Department of Planning and Environment

RE: Wentworth Point Residents Action Group (WPRAG) submission on Wentworth Point High School - Application Number SSD-11802230

Figure 1 - Anti-social behaviour at the Ferry Wharf, the eastern end of Burroway Rd and The Connection at Rhodes

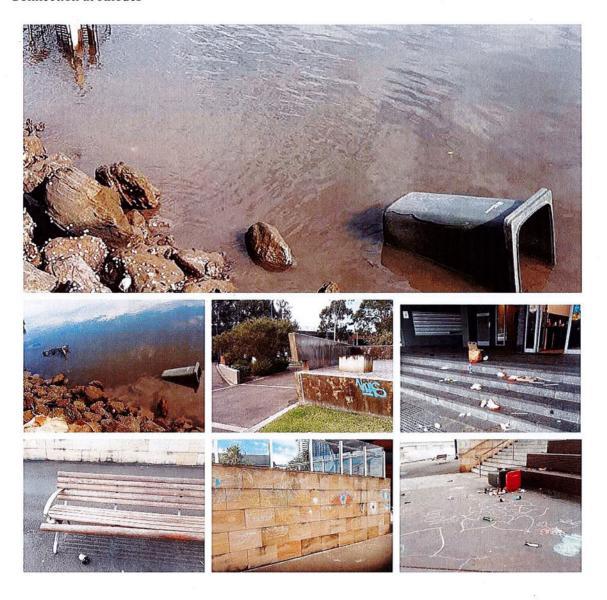
There are already significant issues with anti-social behaviour at the Ferry Wharf, the eastern end of Burroway Rd, The Connection at Rhodes and at the shelters on the Bennelong Bridge. (See Figure 1)

Drug use is already an issue in that area. The police have placed two permanent monitoring cameras on the High School land.

Figure 2 - Rooftop terrace at Parramatta Public School

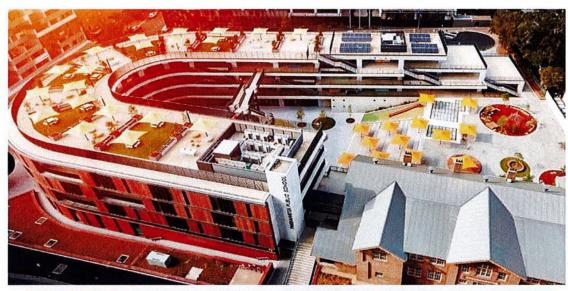
surrounding the Louise Sauvage pathway.	
Playground & recreational facilities: The school does not come close to meeting the required open space ratio of 10sqm per student. The total land area in Stage 1 for the High School is 1 hectare which falls well below the minimum area of 2.5 hectares recommended for High Schools as detailed in the Auditor Generals Report 2021 "Delivering School Infrastructure". A similar combined shared school space for primary and secondary students was developed in Parramatta. Arthur Phillip High School and Parramatta Public School have similar density (though most students at APHS & PPS come from medium or low density suburbs). A total of 27,043 m2 (or 2.7ha) of open space has been provided for both school sites with 8,000m2 on the PPS site, 14,442m2 on the APHS site and 4,600m2 share space — this includes five external sports courts, an ampitheatre, outdoor space for markets, and a roof garden on the PPS site.	The Department of Planning Design Guide for Schools says that they must "Ensure outdoor playground space is sufficient to accommodate the student population including future growth". Arthur Phillip High School, Parramatta. Rooftop courtyard and recreational facilities St Andrew's Cathedral School. Rooftop playground which can double as a social space. Parramatta Public School, Parramatta. Rooftop terrace (See Figure 2)	A mesh-enclosed rooftop playground that can double as a wonderful social space. Students can eat lunch or play games overlooking the Parramatta River & Haslams Creek. Opportunities for school & community gatherings including outdoor learning and markets.
